**AMENDMENT TO THE SPECIFICATION**

**AMENDMENT TO THE DRAWINGS**

Fig. 4

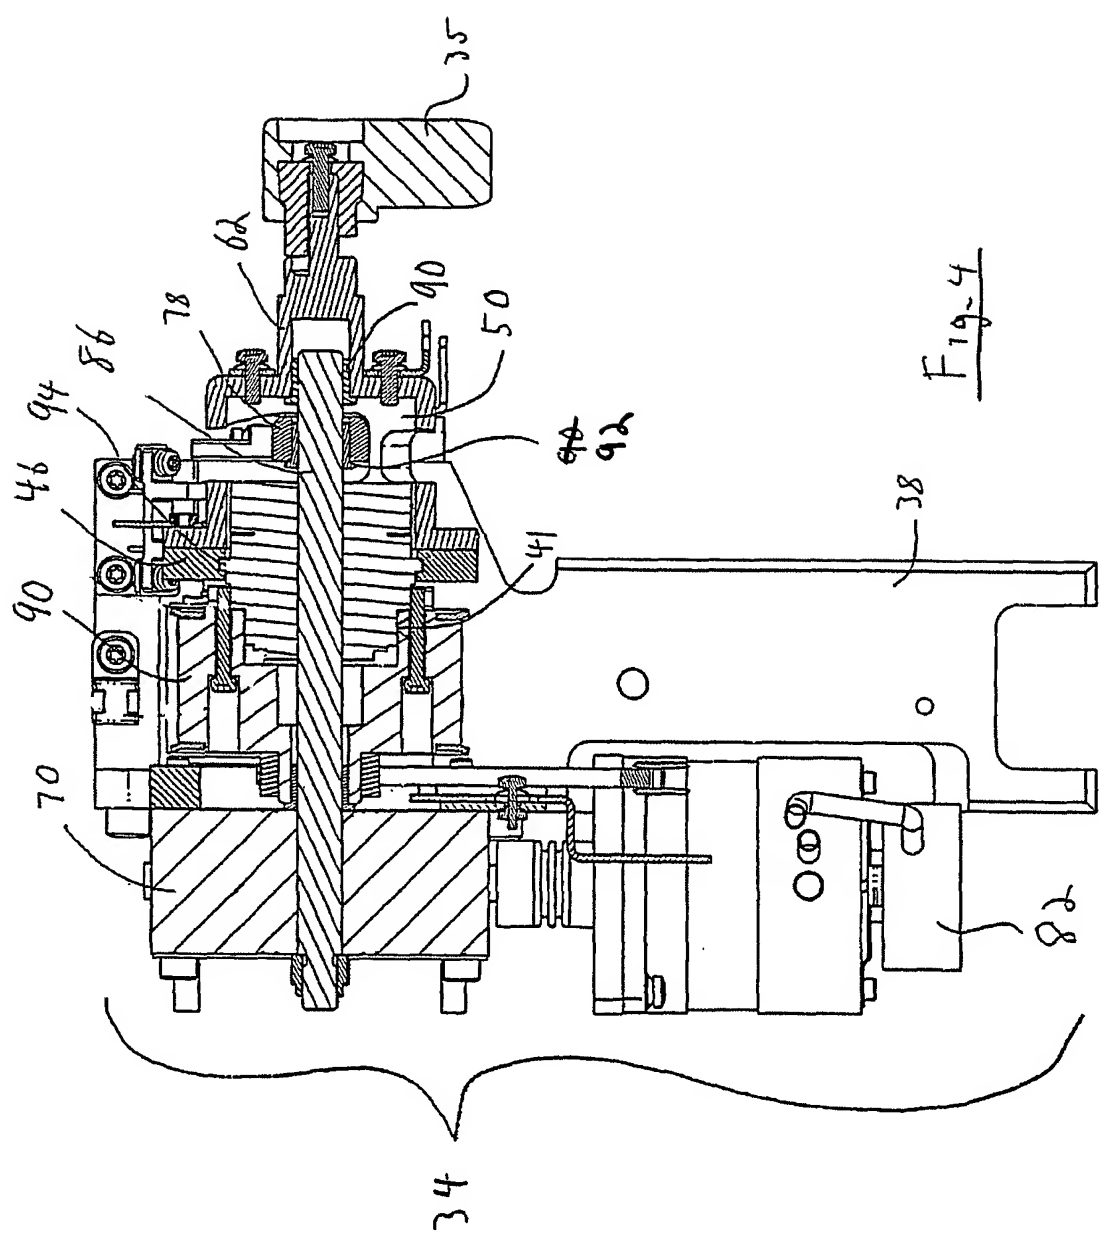
The attached sheets of drawings include changes to Figures 2 and 4. These sheets replace the original sheets including Figures 2 and 4, respectively. In Figure 2, previously omitted element 52 has been added, element 54 has been changed to 55, element 58 has been changed to 57, element 62 has been changed to 61, element 50 has been changed to 53, and element 46 has been changed to 47. In Figure 4, element 90 has been changed to 92.
